ADDENDUM NO. 2 COVER SHEET

November 11, 2024

TERRE HAUTE AIRPORT AUTHORITY
WEST QUAD 6 UNIT BOX HANGAR PHASE 2
at
TERRE HAUTE REGIONAL AIRPORT (HUF)
TERRE HAUTE, IN
AIP 3-18-0082-057-2024

ADDENDUM NO. 2

Layout Tab Name: CG101
 Last Saved By: Sullivan, T
 11/20/2024 10:09:17 AM
 V:\Sullivan\T\Drawings\Terre Haute International Airport\11009658_HUF_Airp-TBD_West Quad_Ph 2\Cad/CadPhase 2\Division A11009658-GRA DIV Actg Plotted By Sullivan, T on 11/20/2024 10:09:17 AM

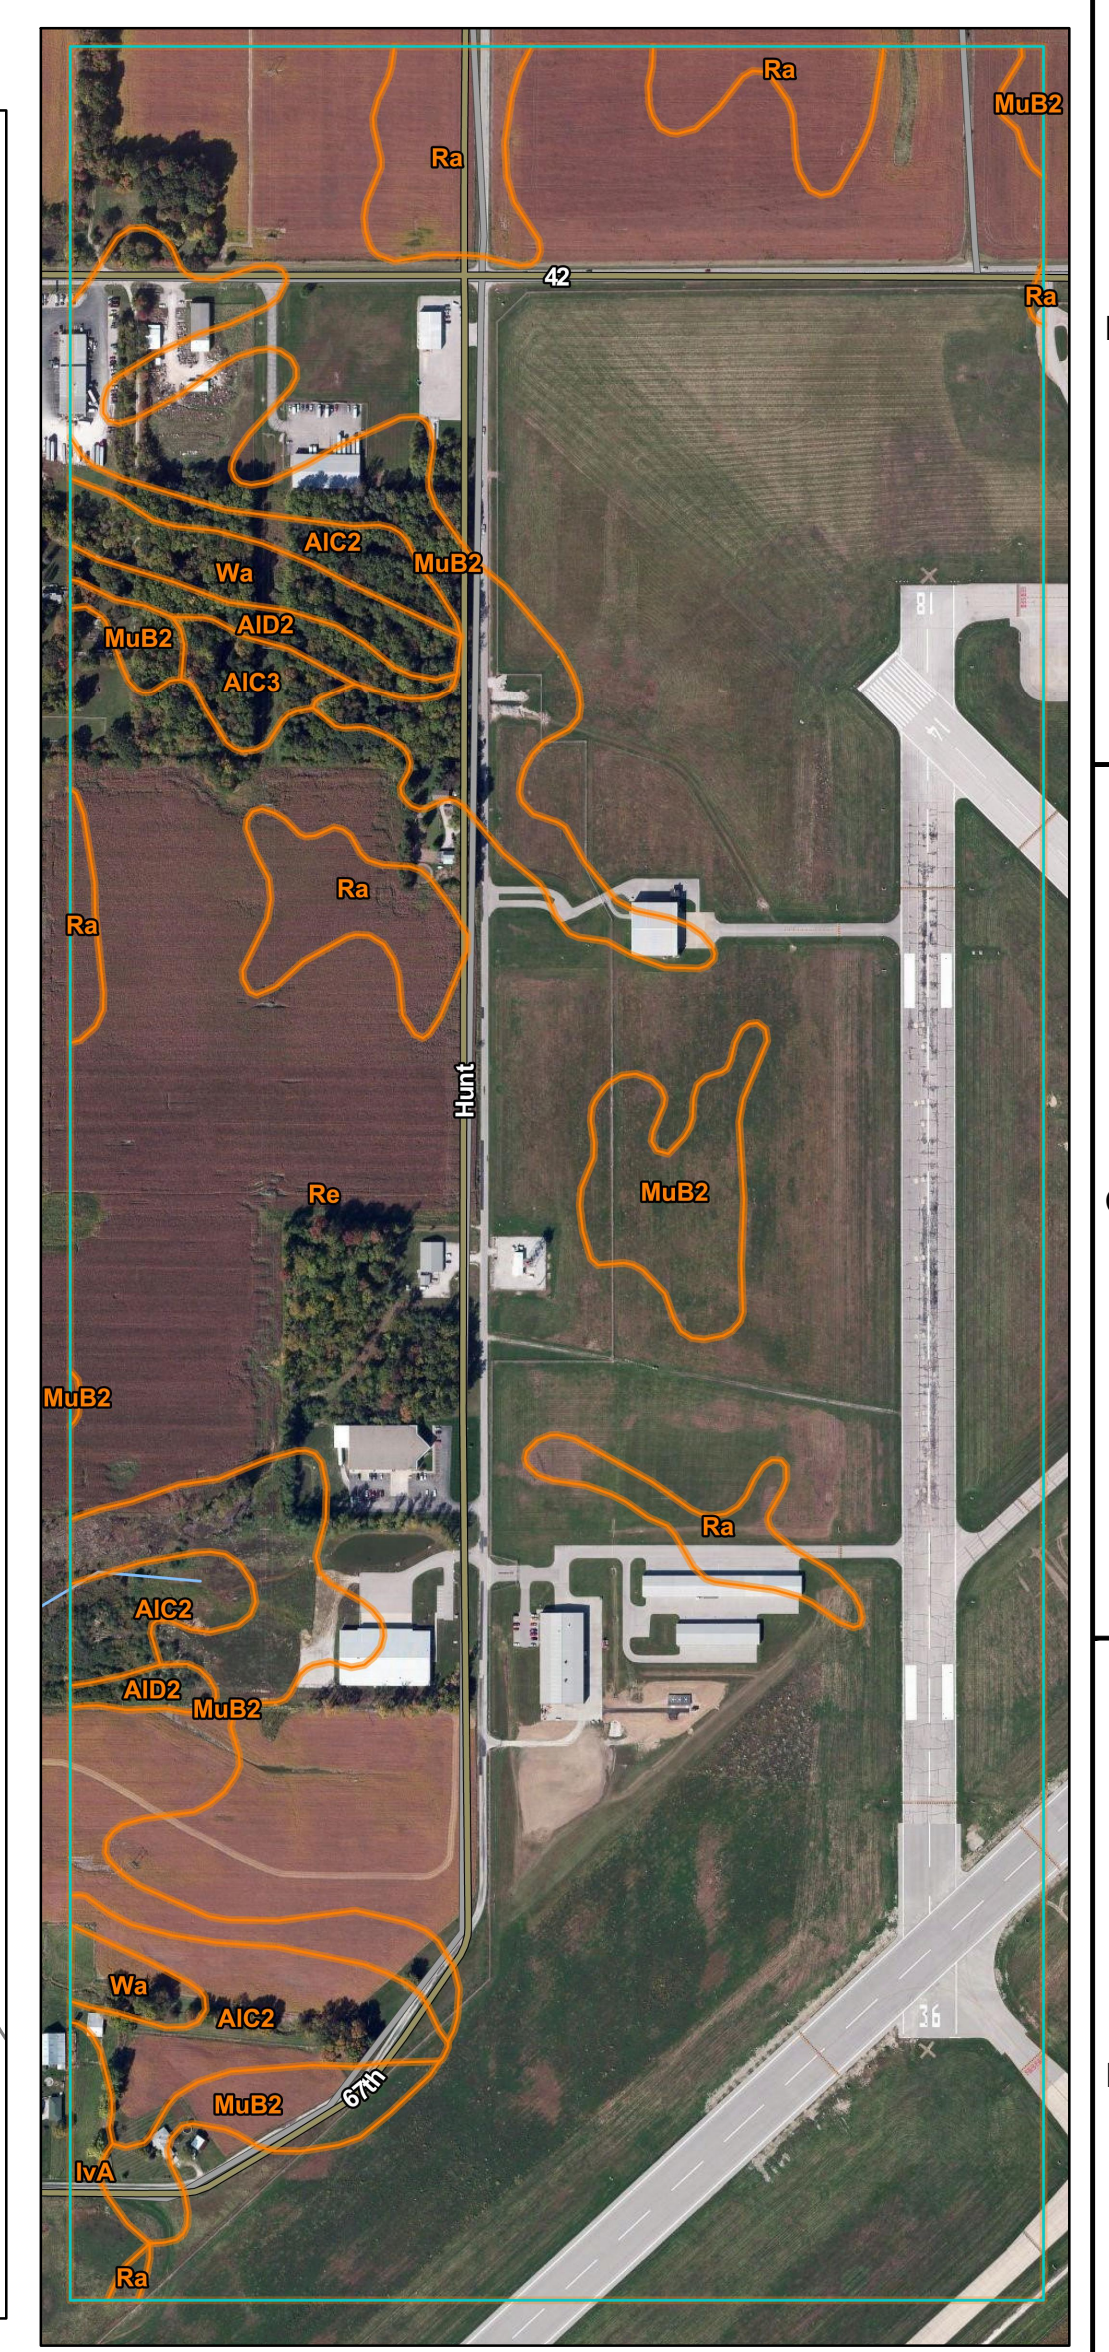
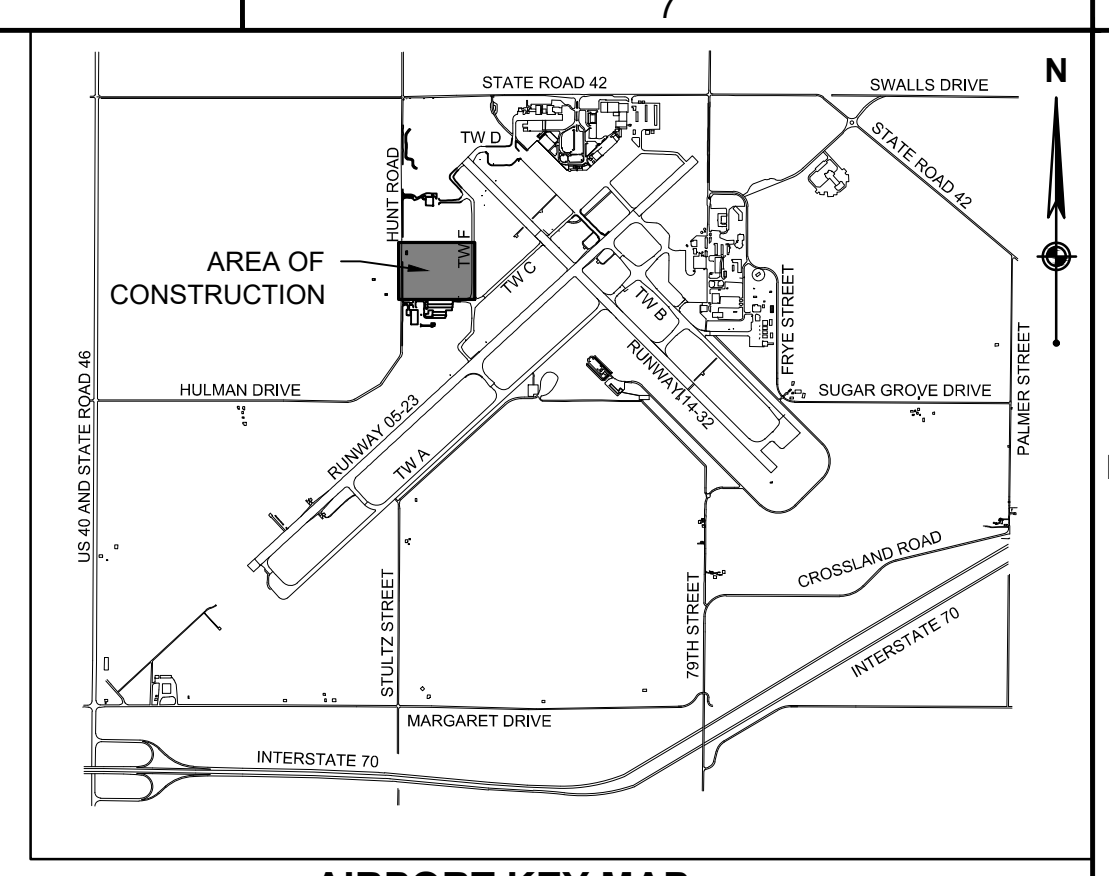
5. **Replace:** "CG101 Grading and Drainage Plan" dated October 18, 2024, with the revised drawing "**CG101 Grading and Drainage Plan**" dated November 8, 2024, issued with this Addendum.

6. **Question:** *Where will the stockpile for surplus soils be located?*
Answer: The stockpile for surplus soils will be located north of the staging area. Refer to CG101.

8. **Question:** *The unclassified excavation unit price quantity on C-002 table does not match the earthwork summary table on CG101.*
Answer: Refer to revised quantity in Addendum No. 2.

Answer: No, refer to CG101, Grading and Drainage Plan, Note 6.
16. **Question:** *Does the bid item "Concrete" also include the stone subbase under the concrete?*

17. **Question:** *There is no bid item for topsoil. Is topsoil required?*
Answer: Topsoil is required. Refer to CG101, Grading and Drainage Plan, Note 16 and Addendum No. 2.
